City of Ketchum

Recommendation to approve the Mindbender Condominiums Subdivision Preliminary Plat

A PRELIMINARY PLAT SHOWING MINDBENDER CONDOMINIUMS

PROJECT: Mindbender Condominium Subdivision Preliminary Plat

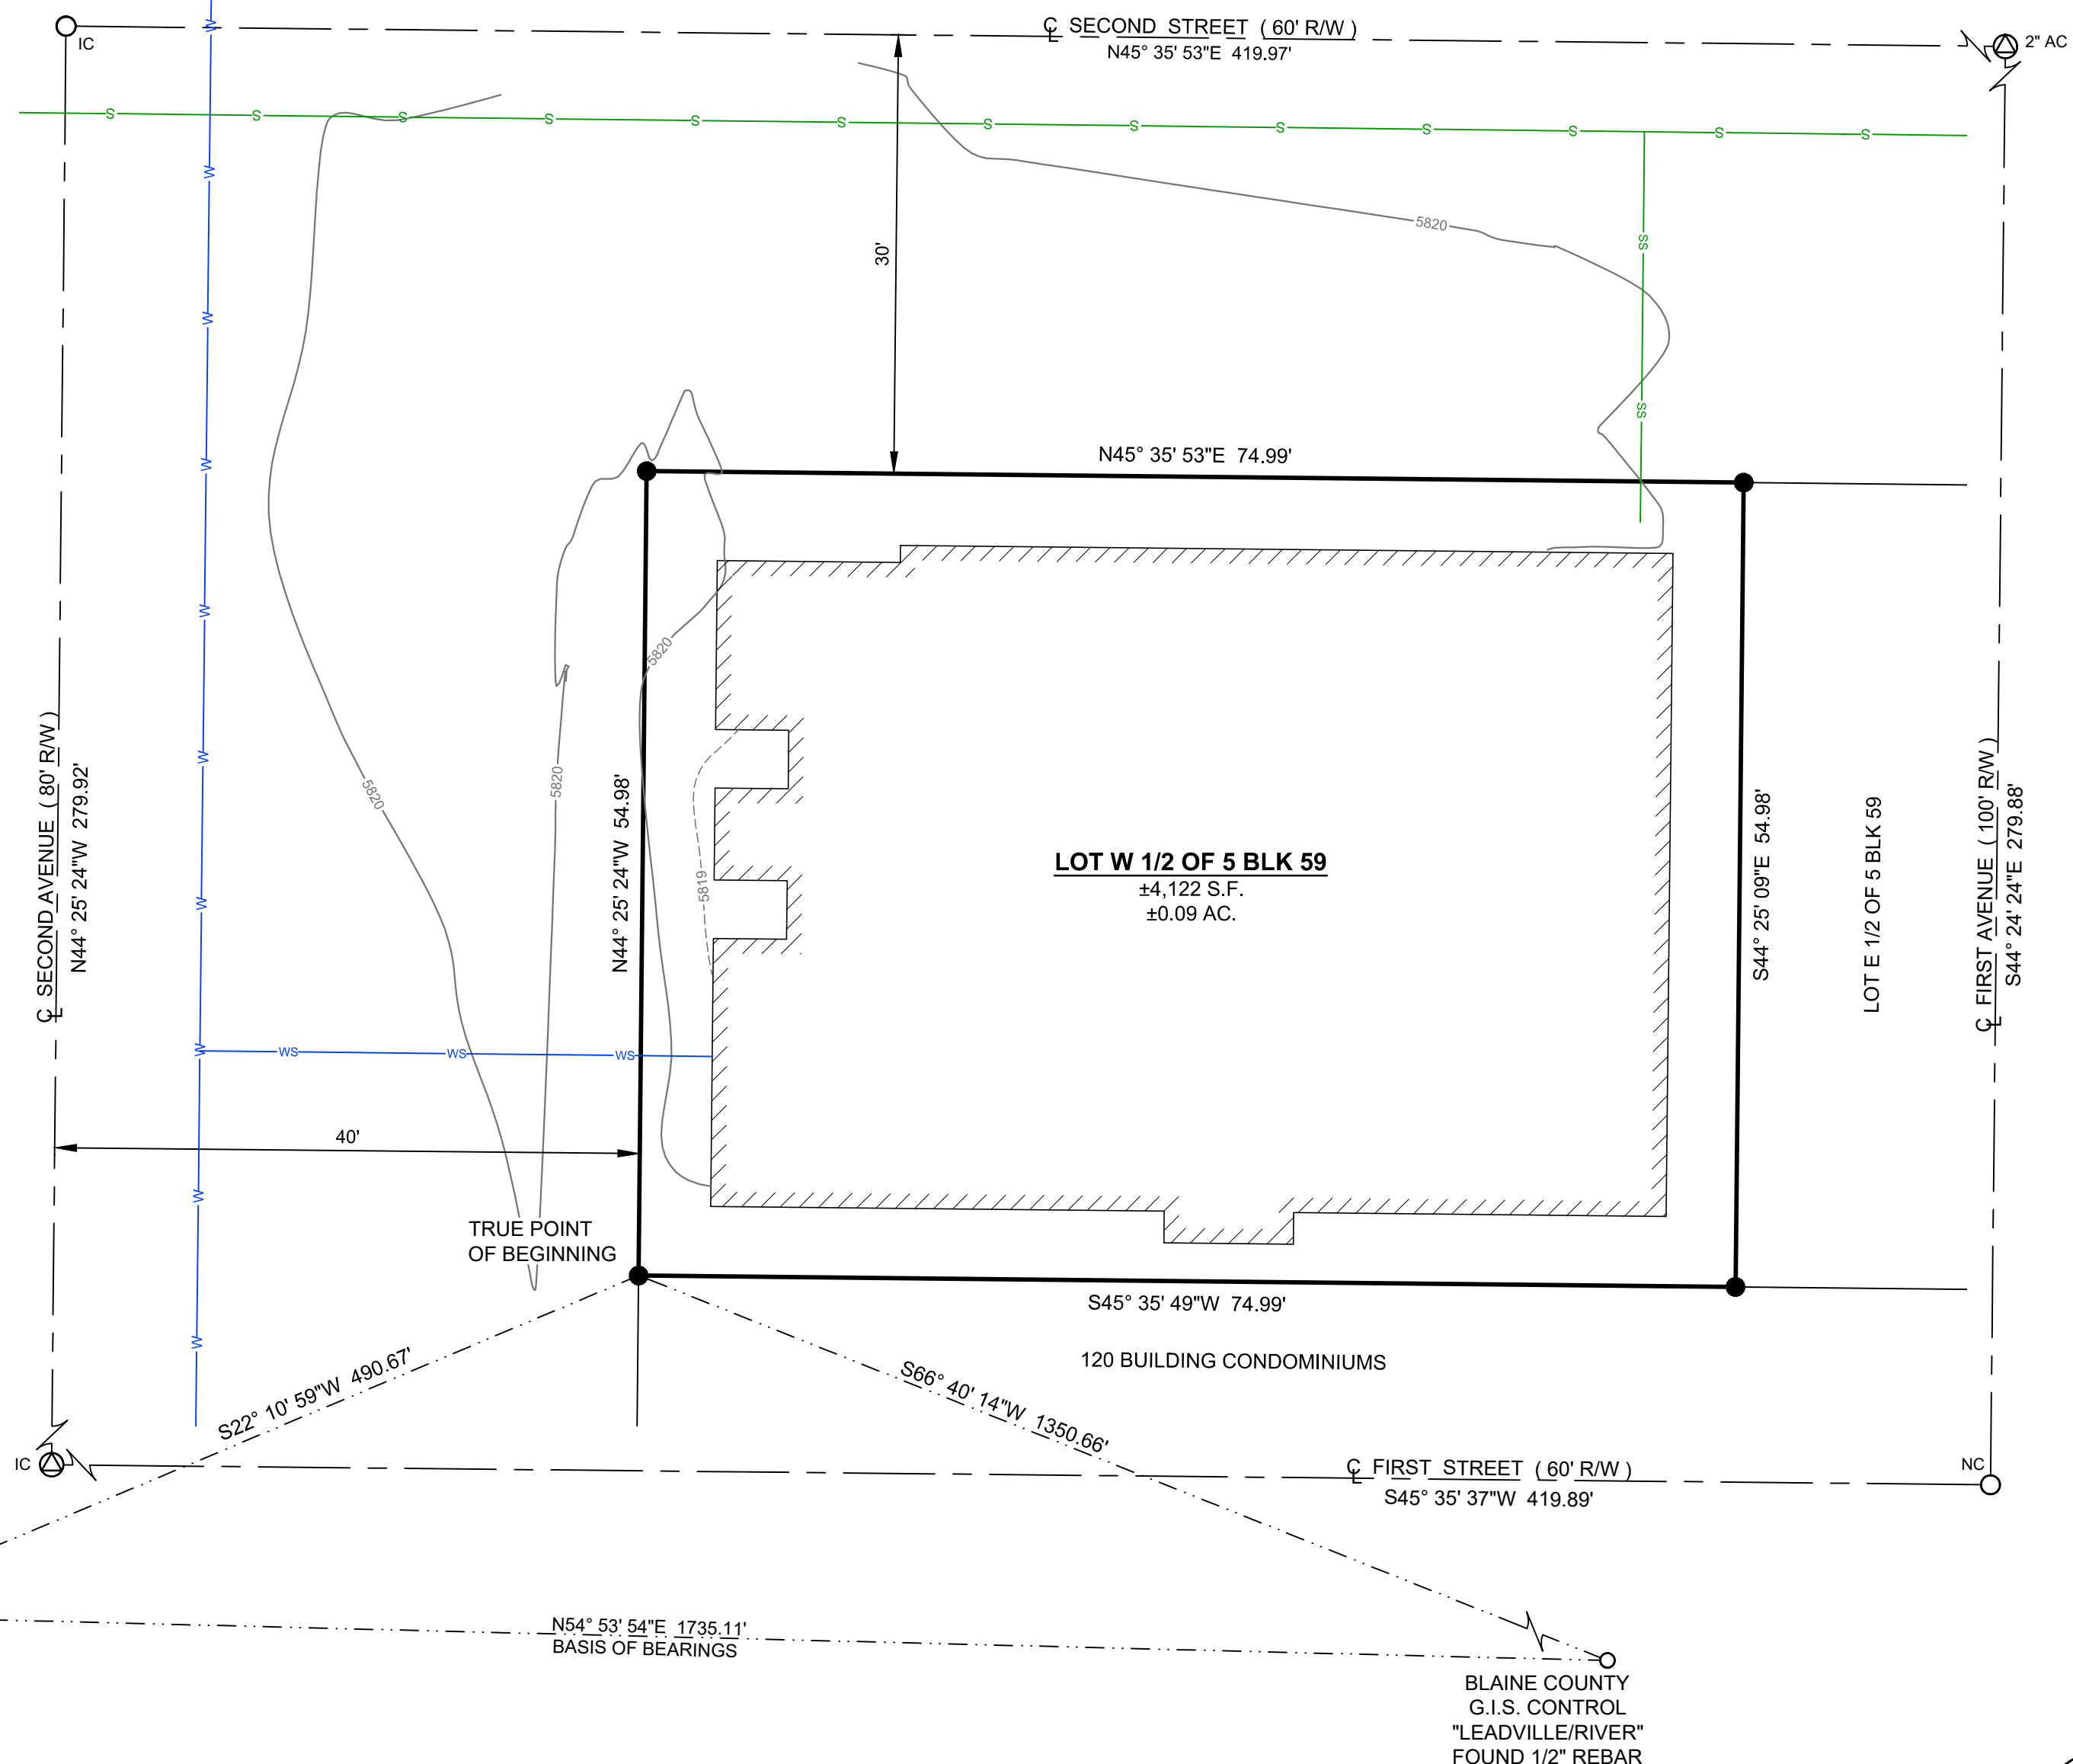
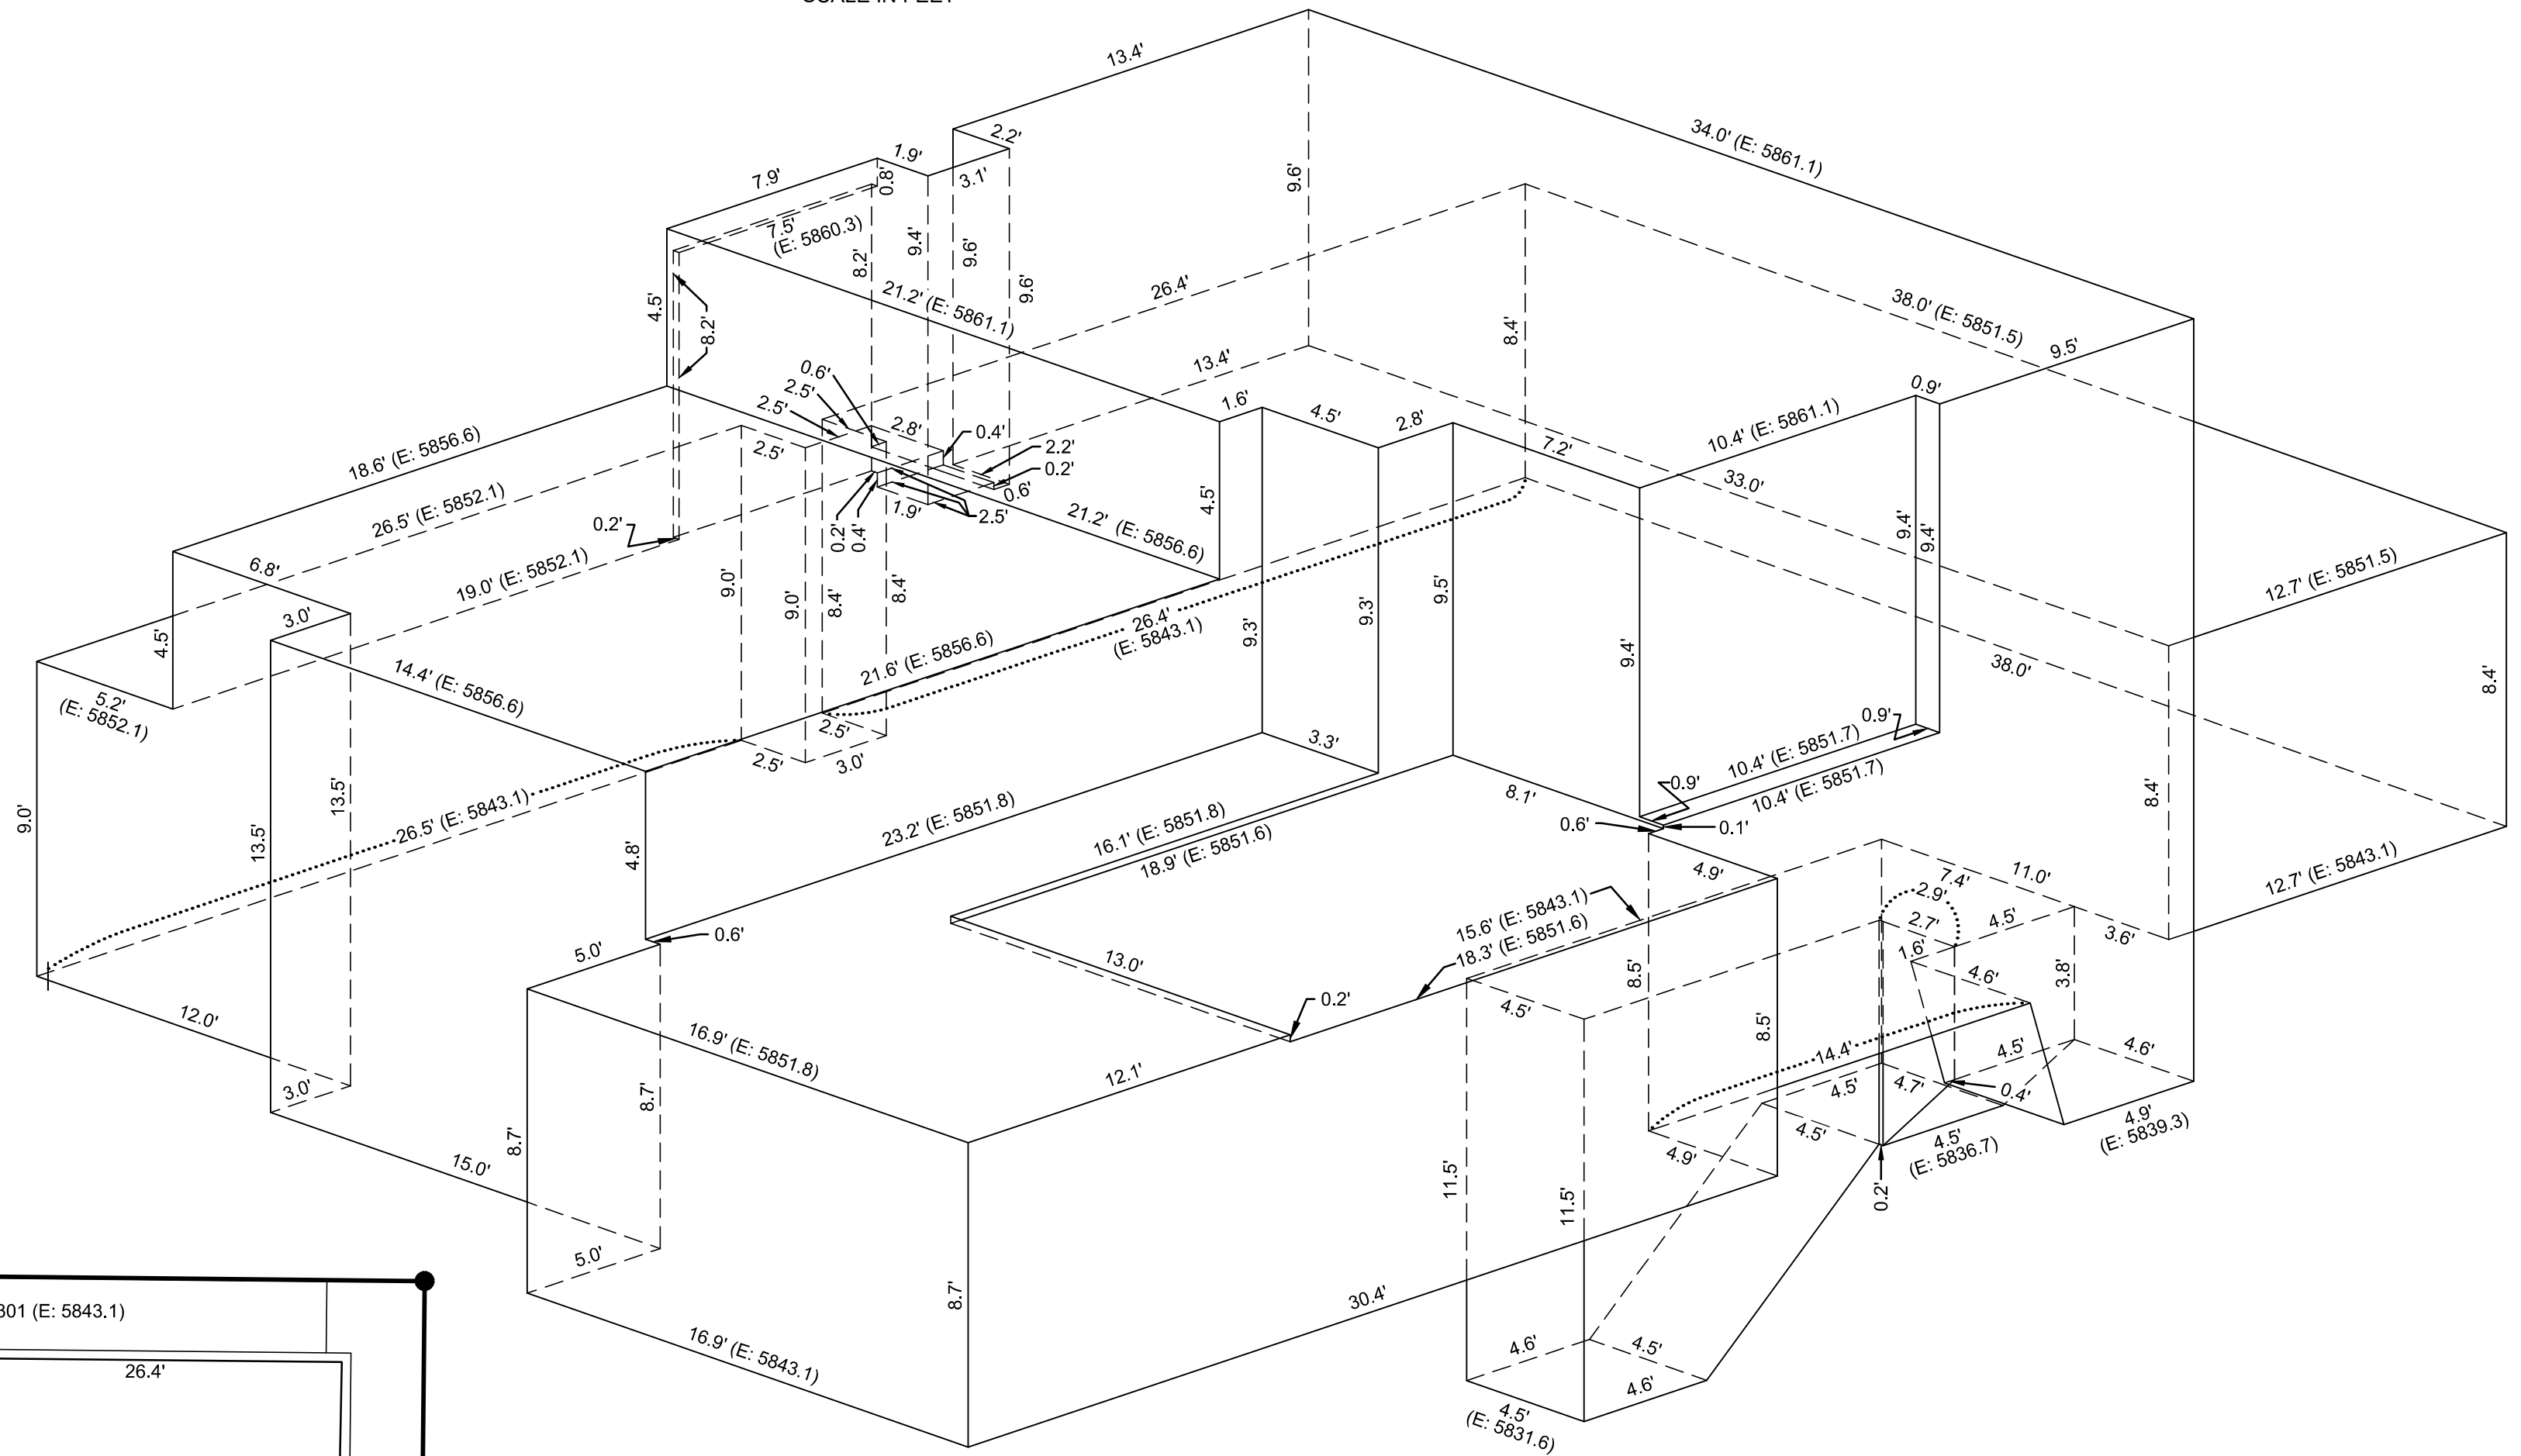
Comments	Contours present

Comments	Common Areas and Limited Common Areas are shown
<input type="checkbox"/>	<input type="checkbox"/>	X	16.04.030.J .12	The location, size and type of sanitary and storm sewers, water mains, culverts and other surface or subsurface structures existing within or immediately adjacent to the proposed sanitary or storm sewers, water mains, and storage facilities, street improvements, street lighting, curbs, and gutters and all proposed utilities.
			Comments	N/A, this application is to plat an existing building that is under construction into condominium buildings.
<input type="checkbox"/>	<input type="checkbox"/>	X	16.04.030.J .13	The direction of drainage, flow and approximate grade of all streets.
			Comments	N/A, this application is to plat an existing building that is under construction into condominium buildings.
<input type="checkbox"/>	<input type="checkbox"/>	X	16.04.030. J .14	The location of all drainage canals and structures, the proposed method of disposing of runoff water, and the location and size of all drainage easements, whether they are located within or outside of the proposed plat.

Comments	Addressed with Plat Note #1

Mechanical rooms are indicated on the plat.
X	<input type="checkbox"/>	<input type="checkbox"/>	16.04.070.G	G. Open Space: The subdivider shall dedicate to the common use of the homeowners adequate open space of such shape and area usable and convenient to the residents of the condominium subdivision. Location of building sites and common area shall maximize privacy and solar access.
				Units 101 and 102 have outdoor spaces located at the entries of the units, albeit small. Units 201 and 301 have extensive outdoor deck space indicated as Limited Common areas associated with these units.
X	<input type="checkbox"/>	<input type="checkbox"/>	16.04.070.H	H. General Applicability: All other provisions of this chapter and all applicable ordinances, rules and regulations of the city and all other governmental entities having jurisdiction shall be complied with by condominium subdivisions
				All requirements associated with the Building Permit and Design Review approvals remain in effect.
